UNITED STATES PATENT AND TRADEMARK OFFICE

APPLICATION NO.	FILING DATE	FIRST NAMED INVENTOR	ATTORNEY DOCKET NO.	CONFIRMATION NO.
10/766,798	01/28/2004	Paul C. Probst	PROB100USA	3999
24339	7590	06/12/2007		
JOEL D. SKINNER, JR. SKINNER AND ASSOCIATES 212 COMMERCIAL ST. HUDSON, WI 54016			EXAMINER EDELL, JOSEPH F	
			ART UNIT 3636	PAPER NUMBER
			MAIL DATE 06/12/2007	DELIVERY MODE PAPER

Office Action Summary

DETAILED ACTION

Annotated Figure 3 of Pistay

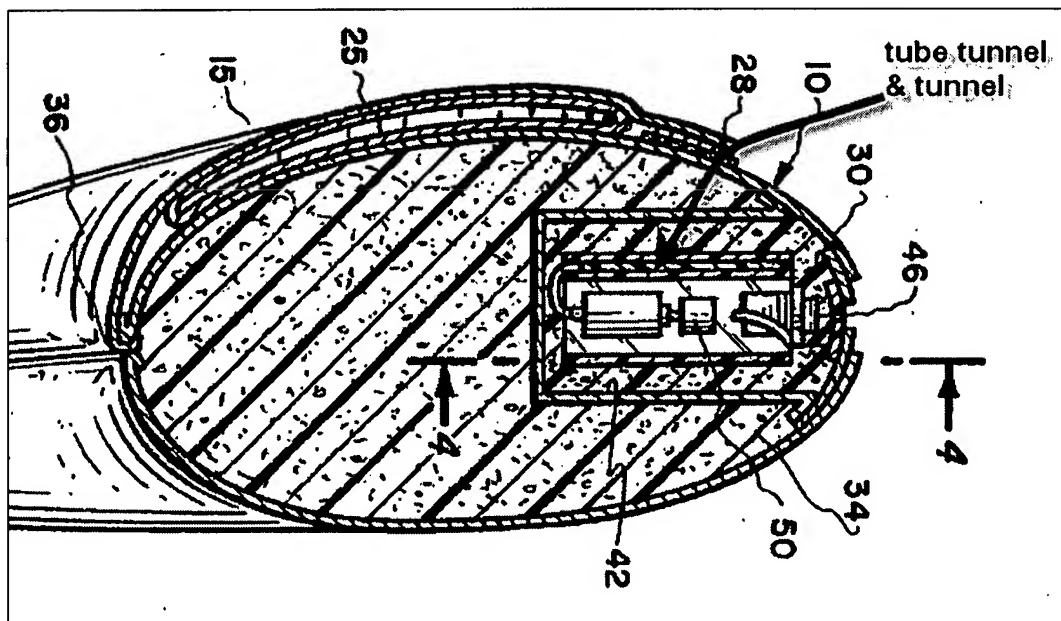
Turudich discloses a seat that is basically the same as that recited in claims 1, 4, 10, and 20-24 except that the seat lacks a tube tunnel and tube, as recited in the claims. See Figures 1-4 of Turudich for the teaching that the seat has a shell 13 (see Fig. 2), spaced apart rods 18,19, an electric vibratory, oscillating motor mechanism 11, a power source 25 connected to the motor mechanism, and a control 26 connected to the motor mechanism and power source wherein the motor vibrates at frequencies above 3000 RPM and the seat is made of composites and the motor mechanism and power source extend along a long axis of the seat. Pistay shows a seat similar to that of Turudich wherein the seat has a concave tube tunnel (see Diagram A below), a tube firmly disposed within and filling the tube tunnel, and a vibratory, oscillating motor mechanism 44 (see Fig. 4) within the tube. Therefore, it would have been obvious to one having

ordinary skill in the art at the time the invention was made to modify the seat shell such that it includes a tube tunnel affixed to the underside of the seat shell and extending front to back along the length of the seat and in communicative contact with the rods, a tube firmly disposed within and filling the tube tunnel, and the motor mechanism and power source being in the tube, such as the seat disclosed in Pistay. One would have been motivated to make such a modification in view of the suggestion in Pistay that the tube tunnel and tube configuration allows for the entire configuration to be removed from the seat for maintenance. Moreover, the tube tunnel and tube housing the motor mechanism and power source would have been obvious to one skilled in the art when taking into account the inferences and creative steps that one skilled in the art would employ.
